DECLARATION OF THE RECORD OF DECISION

Pennsylvania Avenue Landfill
Borough of Brooklyn
Kings County
Site Code: 224002
Funding Source: 1986 Environmental Quality Bond Act

APPENDIX A: RESPONSIVENESS SUMMARY

FIGURE 3 - APPROXIMATE EXTENT OF FRESH CREEK SEDIMENT REMEDIATION

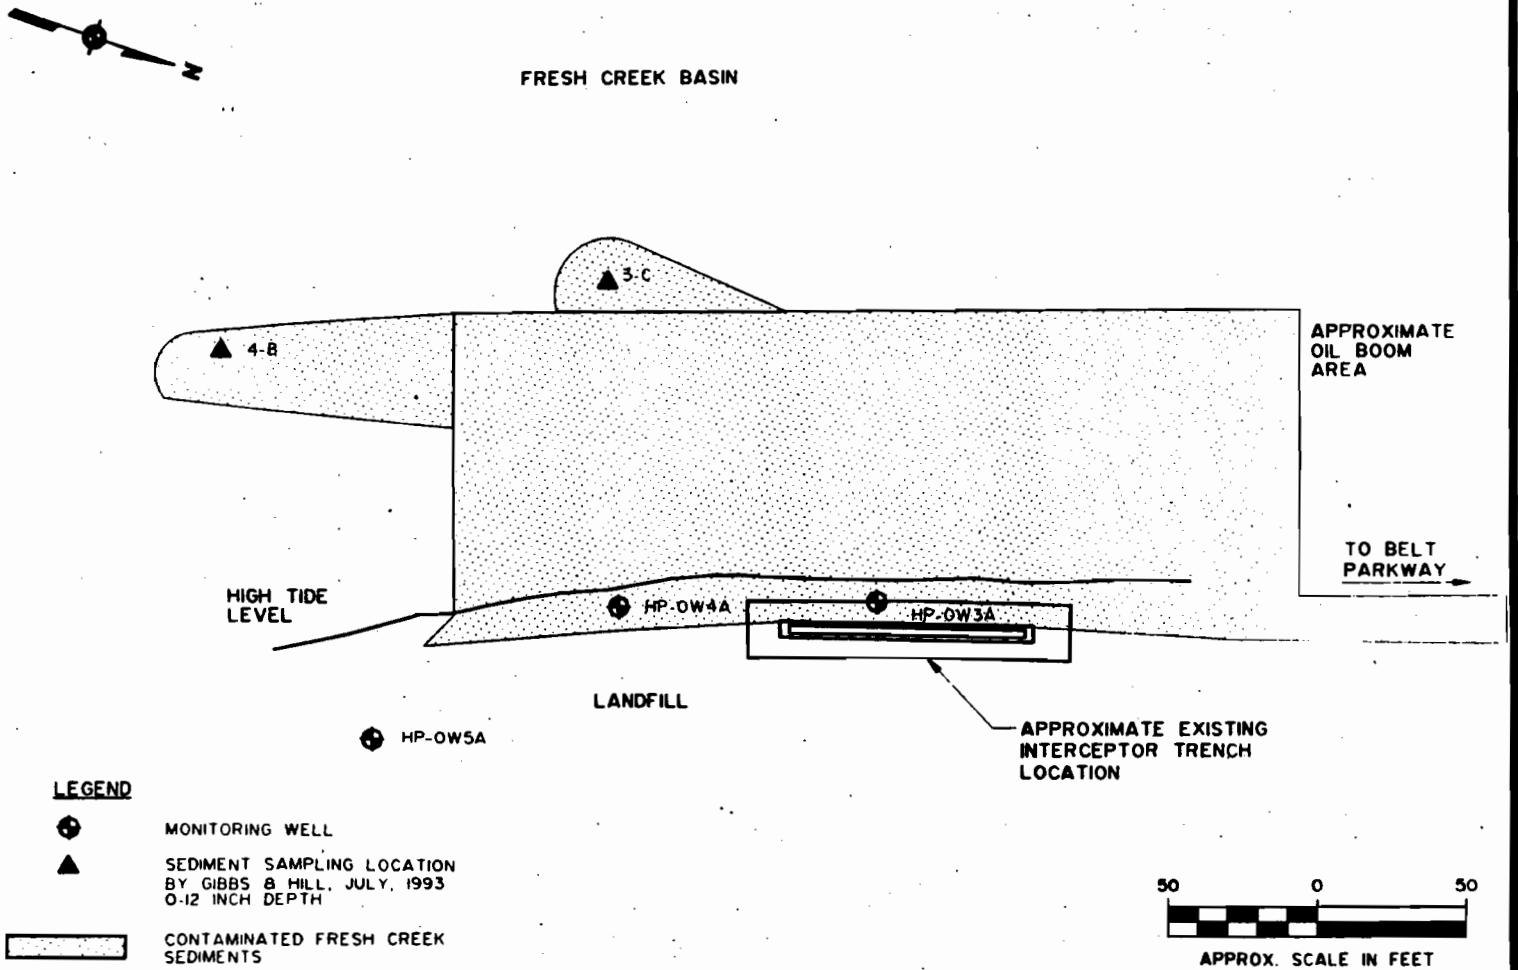
Comment: Additional leachate collection and sediment remediation is necessary

- Excavation of sediments in the area of the waste oil outbreak as indicated in Figure 3. Generally, the cleanup goal for this limited excavation would be to remove visibly oil-stained material and PCBs at levels exceeding 1 ppm. Sampling conducted within the boom area found only one location where PCBs exceeded 1 ppm, suggesting that removing visibly stained sediments would also achieve the PCB cleanup goal. The estimated 5,000 cubic yards (cu yds) of contaminated sediments would be dewatered and placed on the landfill prior to capping.

FIGURE 4 - LANDFILL CAP CROSS SECTION

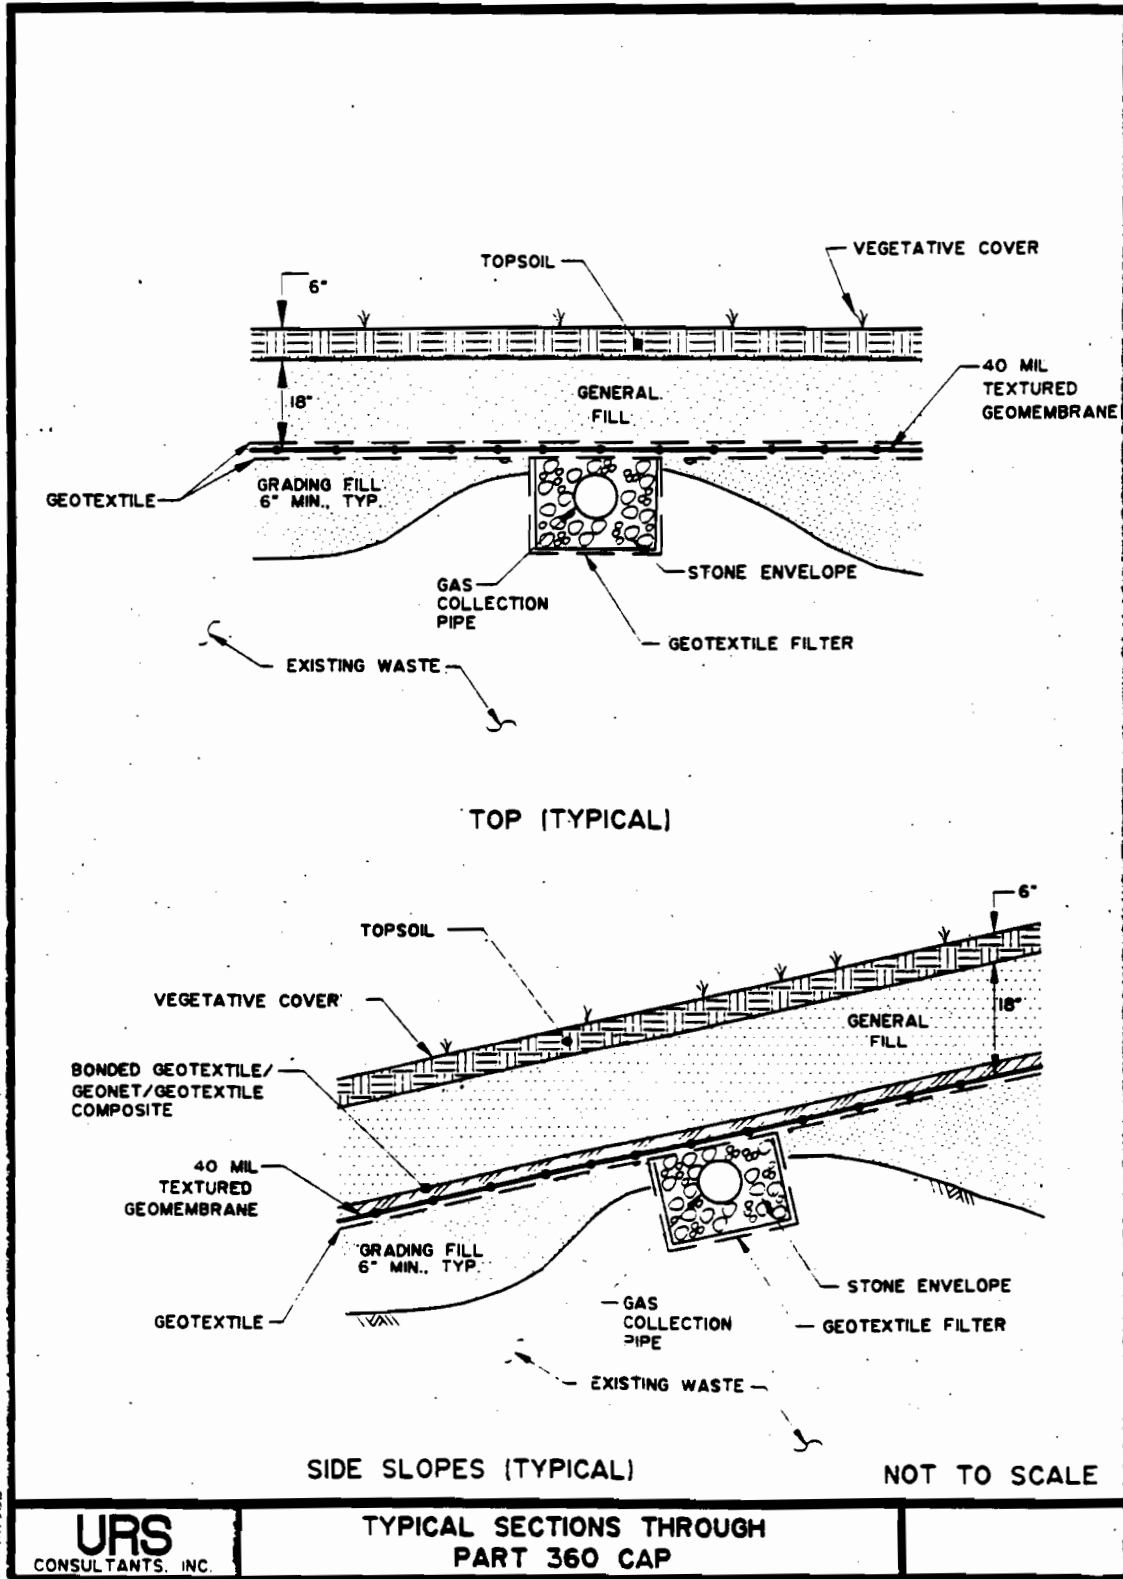
Issue: 1) While the FS recommended that the geomembrane component of the cap system should be 40 mil VLDPE, consideration of a 60 mil HDPE should be retained during the Design phase. 2) Suggestions were made to revise the remedial timeframes for several alternatives in the PRAP so they are consistent with those reported in the Feasibility Study. 3) Several clarifications and corrections were made to the costs of product recovery alternatives at PAL, to the acreages of the combination cap alternatives and to the present worth of FAL Alternative 8. 4) The Fresh Creek sediment remediation alternatives specified remediation of visibly contaminated sediments in addition to areas where PCB levels exceeded 1 ppm. 5) Creation of lined freshwater wetlands should also be considered in the valley area of FAL, where settlement of waste is not expected to be as great.⁵

Issue: The proposed variance to the 24" barrier protection layer should not be granted because this would not provide sufficient protection to the synthetic membrane, and because it would provide no margin for error in constructing this layer.⁹

Response: DEC agrees with issues 1, 3, 4 and 5, and has included these in the Record of Decision. With regard to the creation of lined wetlands overlying waste areas, the location of DEP's proposed wetland, at the foot of the FAL valley, is proposed as part of the surface drainage plan for the site, and is not intended to reduce the amount of grading or regrading. DEC will consider a specific proposal for such a pond during the remedial design phase. With regard to issue #2, DEC believes that the remedial timeframes listed in the Pennsylvania Avenue Landfill PRAP for the alternatives in question are reasonable. For instance, the Feasibility Study lists 48 months as the remedial timeframe for alternatives that provide full sediment excavation with various capping options. DEC believes that, by conducting sediment excavation activities while the leachate collection system and portions of the landfill cap are under construction, Alternatives 5, 9, and 13 can be constructed in 36 months. Similarly, product recovery could be implemented in the waste oil area while the remaining portions of the cap are under construction, so that Alternatives 6 and 10 can be implemented in 36 months. For the duration of Fountain Avenue Landfill Alternatives, DEC agrees that constructing offloading facilities and importing fill materials will extend the timeframe to 3-4 years. However, because perimeter leachate collection and sediment remediation could be performed concurrently with grading activities, the remedial timeframes for Alternatives 5, 6 and 8 are also estimated to be 3-4 years.

Response: DEC believes that a Construction Quality Assurance Plan will be developed that can ensure that the barrier protection layer will be a uniform 18" across the sites, and that a 6" grading error is highly unlikely. If NYCDEP can demonstrate that the combined 24" barrier protection and vegetated topsoil layers above the cap will provide adequate protection to the

membrane, DEC will grant the variance. DEC will ensure that the final vegetative plan is consistent with this reduced soil thickness and if enhanced vegetative cover is proposed, that additional soil cover is provided to protect from root penetration.
